Model: Model K-P1 Date			e: 07-Apr-01	1	No.: MG058001		
Modified Article: Parts Catalog Corrections				Prepared by: K. Misugi			
From: Technical Services Dept., GTS Division				•			
Reason for	□ Parts catalog correction	☐ Vendor	r cha	ange	☐ To n	neet standards	
Modification:	☐ To facilitate assembly	☐ To improve reliability		()		
	☐ Part standardization	Other

Please note the following Parts Catalog corrections and component modifications applied to improve reliability:

Modification Bulletin

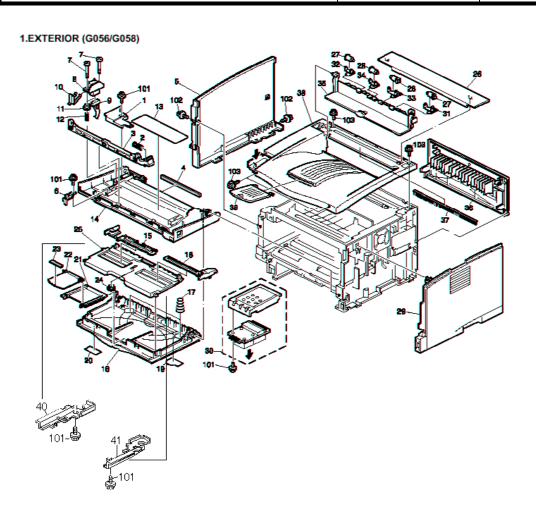
Base - Manual Feed (Bypass Tray) in the K-P3 has been modified to prevent paper feed noise during developing. The same change was also applied to these products: K-P1/K-P2. **Note:** This applies to all models: K-P2, G073/G074 as well as K-P1, G056/G058.

Old part	New part	Description	Q'ty	Int	Page	Index	Note
number	number						
G0523273B	G0763273	Base - Manual Feed : Adhesion	1→1	X/O	3	25	1
	G0763281	Supporting Plate:Base:ManualFE	0→1		3	40	1
	G0763282	Supporting Plate:Base:ManualFE	0→1		3	41	1
	G04503008B	Tapping Screw – M3×8	0→1		3	101	1
	04503008B

Note1: The above parts should be replaced together as a set.

7.CASSETTE (G056/G058)

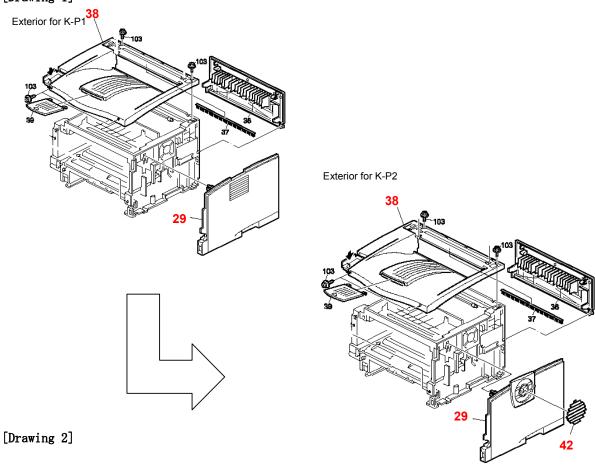
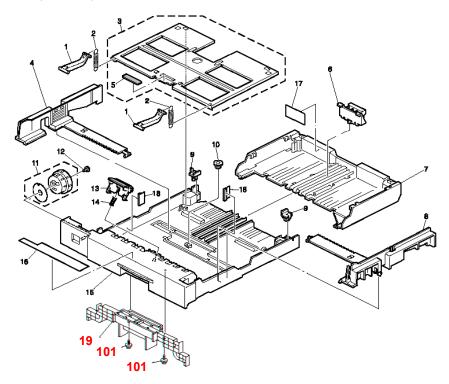
- **1.** The upper cover has been changed due to parts standardization with K-P2. The above parts should be replaced together as a set. Please refer to illustration #1.
- 2. These changes come from the addition of the paper tray grip. These changes are the same as for K-P2.Please refer to MG073006 for details as well as illustration #2.
- **3.** Added to the accessory to cover the rear part of the tray to protect paper from paper dust accumulation. Please refer to MG058002 for details
- **4.** This modification uses the same part and material as for the K-P3.

Old part	New part	Description	Q'ty	Int	Page	Index	Note
number	number						
G0521522	G0751652	Upper Cover – EUR/Asia	1→1	X/O	3	38	1
G0521565	G0751650	Right Cover	1→1	X/O	3	29	1
	G0751651	Louver	0→1		3	42	1
G0523046	G0763049	Paper Tray Ass'y – EUR/Asia	1→1	X/O	15	*	2
G0523061	G0763061	Paper Tray - Front	1→1	X/O	15	15	2
	G0763063	Grip - Paper Tray Ass'y	0→1		15	19	2
	04503008B	Tapping Screw - M3×8	0→1		15	101	2
	G0523111	Paper Tray Rear Cover	0→1		11	28	3
G0521103	G0881103	Gear – PCU	1→1	X/O	21	18	4

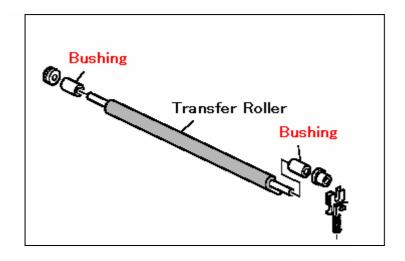
Change/Reason: Parts standardization with the next model (Model K-P4).

Important: All of the new parts in the table must be installed <u>together as a set</u>. You cannot install the new parts individually.
